**विषय :-** Proposal seeking prior approval of the Central Government under Section 2 of the Van (Sanrakshan Evam Samvardhan) Adhiniyam, 1980 for the non-forest use of 455.1108 ha of forest land for Pachwara South Coal Block project in favour of M/S Neyveli Uttar Pradesh Power Limited (NUPPL) District Dumka, Jharkhand (Online no.- FP/JH/MIN/59823/2020) regarding .

Proposal for the non-forest use of 455.1108 ha of forest land for Pachwara South Coal Block project in favour of M/s Neyveli Uttar Pradsh Power Ltd. (NUPPL), District Dumka, Jharkhand-reg.

<b>Sub:</b>	Compliance to the EDS raised by MoEF & CC, Communicated through DFO, Dumka-Letter No. 1639; dt. 15.07.2024 in respect of the FC proposal of Pachwara South Coal Block.
<b>Ref:</b>	Proposal No. FP/JH/MIN/59823/2020 Dated 20/11/2020 for seeking prior approval of Central Government under Section 2 of the Forest (Conservation) Act,1980 for diversion of forest area.

# COAL EVACUATION ROUTE PLAN FOR PACHWARA SOUTH COAL MINE, DUMKA RAJMAHAL COALFIELD, JHARKHAND

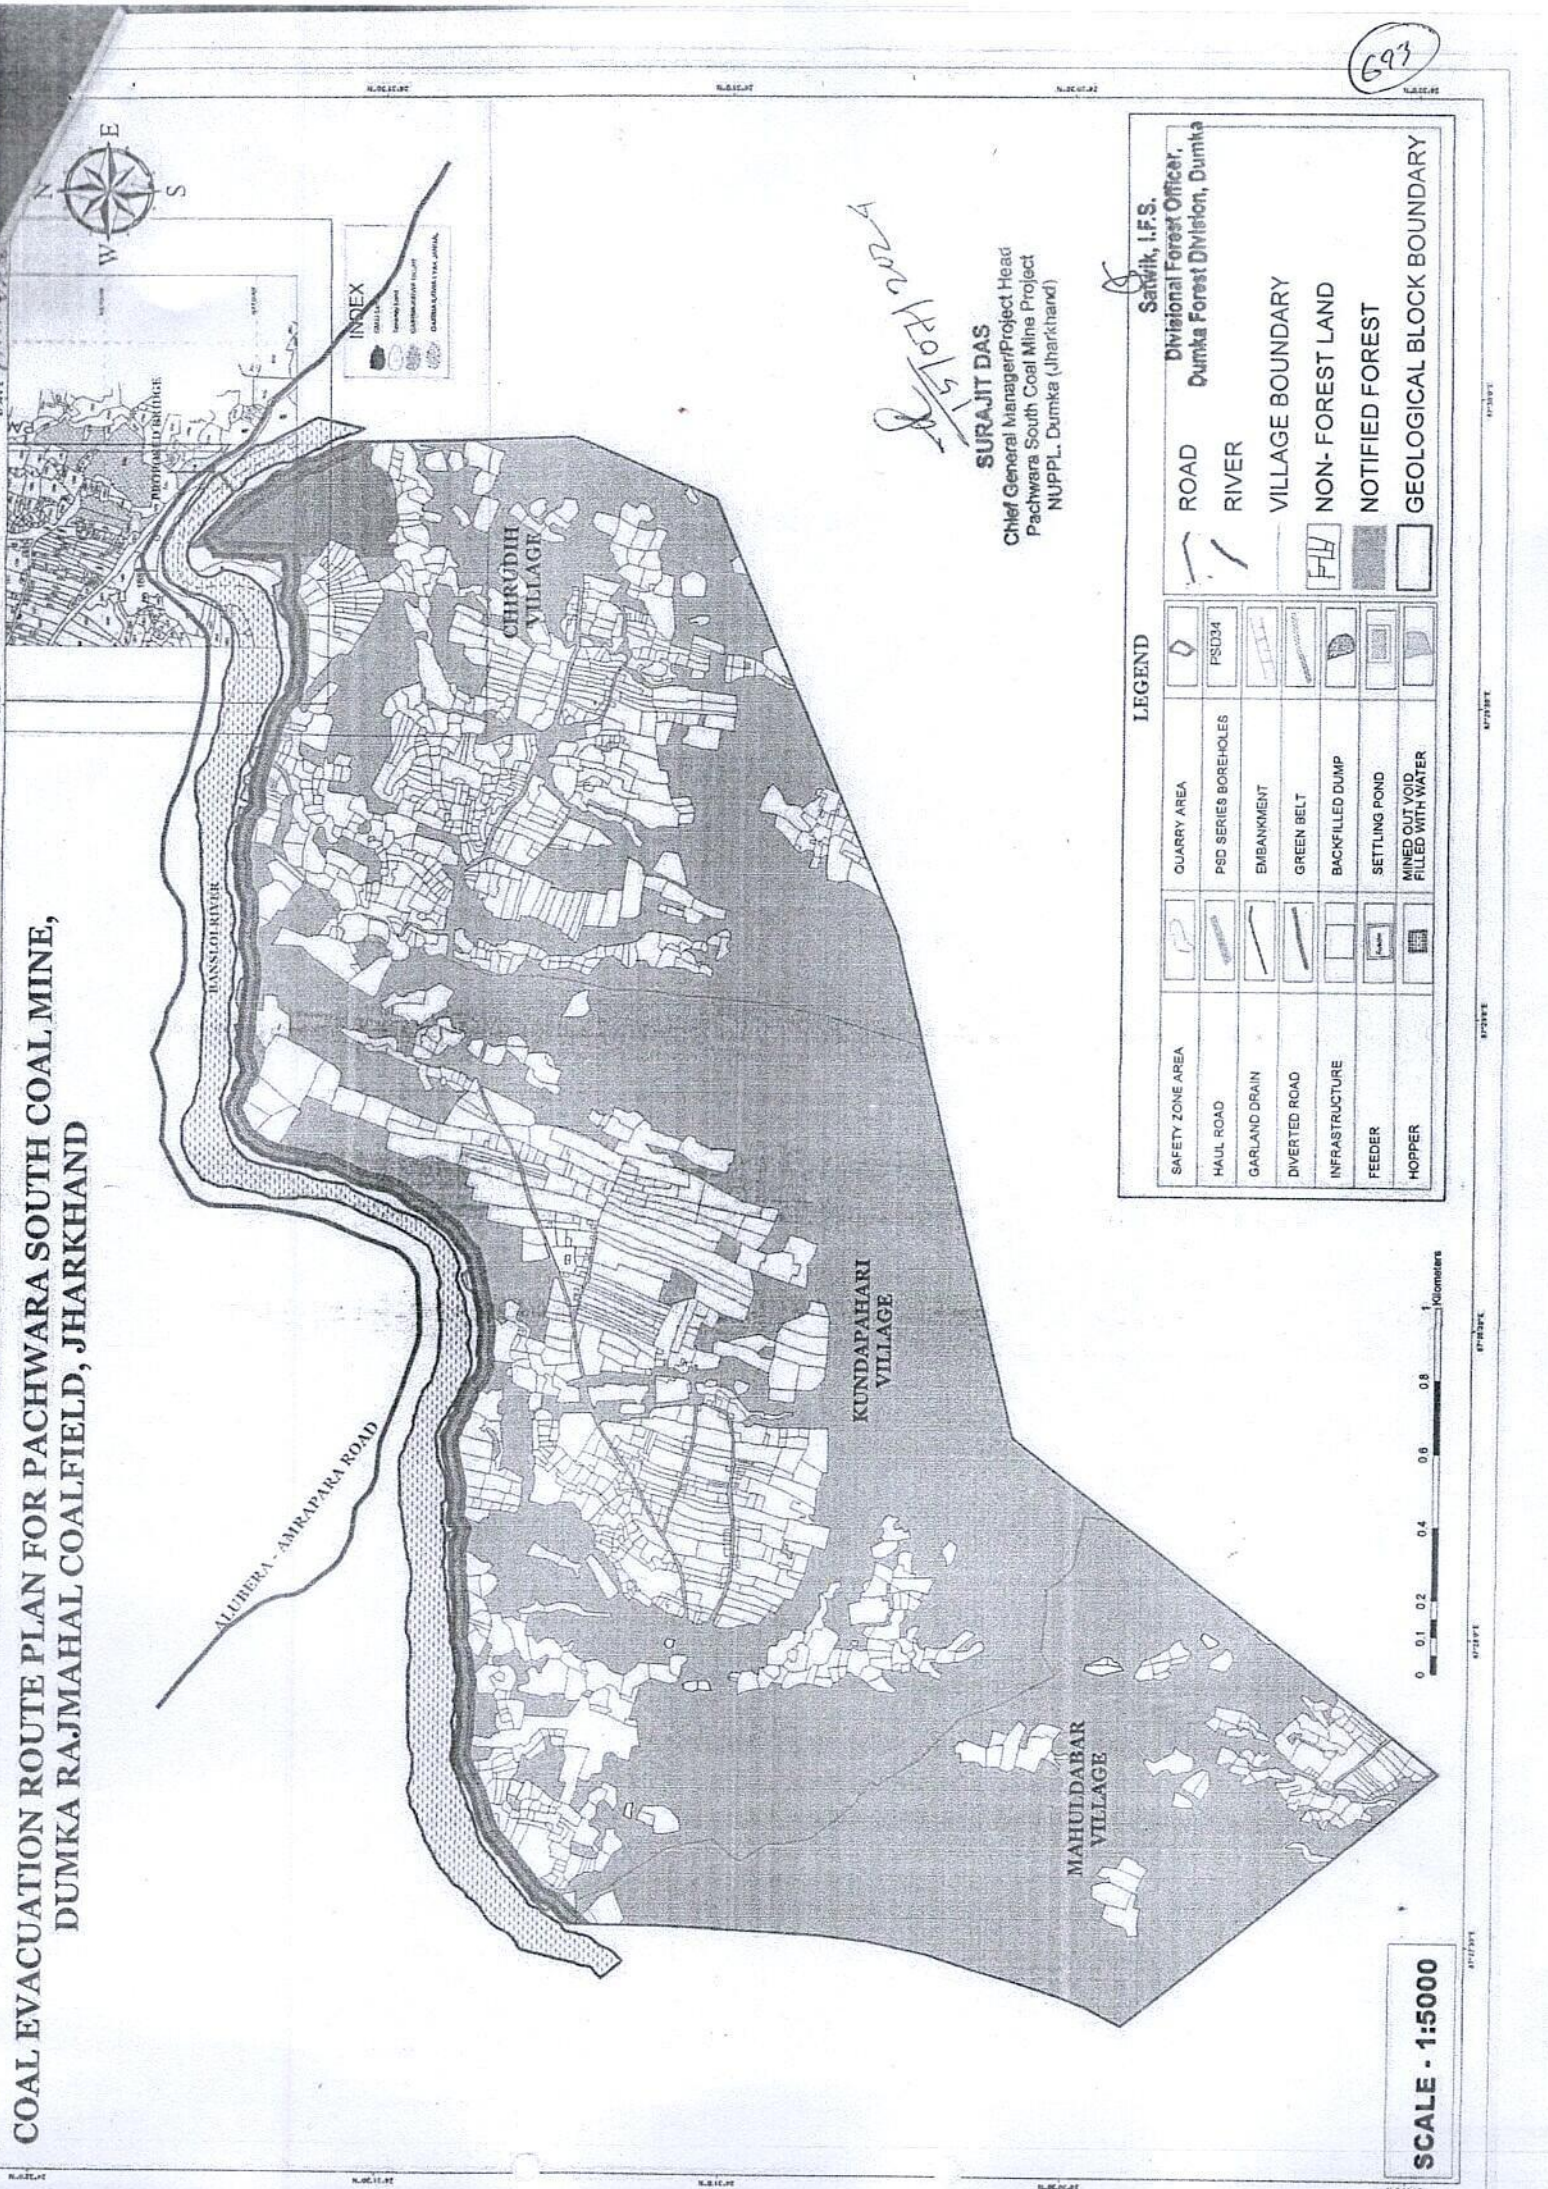
from Project Elephant Division of the Ministry keeping in view the presence of elephants in the area.	MoEF & CC.
3.	As per DSS analysis it was observed that in order to connect the mine with the existing road on a northern bank of Bansloi river, a bridge construction would be required. The State needs to confirm whether any additional forest land would be required for the bridge construction or not.	In order to cross Bansloi river, construction of Bridge is inevitable. A bridge will be constructed to connect existing road in the northern bank of Bansloi river to connect Amrapara from where coal transportation vehicles will be enruoting towards Kurwa Siding (Dumka).  The connecting bridge and associated transportation road does not involve any additional forest land. The layout of the bridge plotted in the cadastral plan is furnished in <b>Annexure-I</b> .
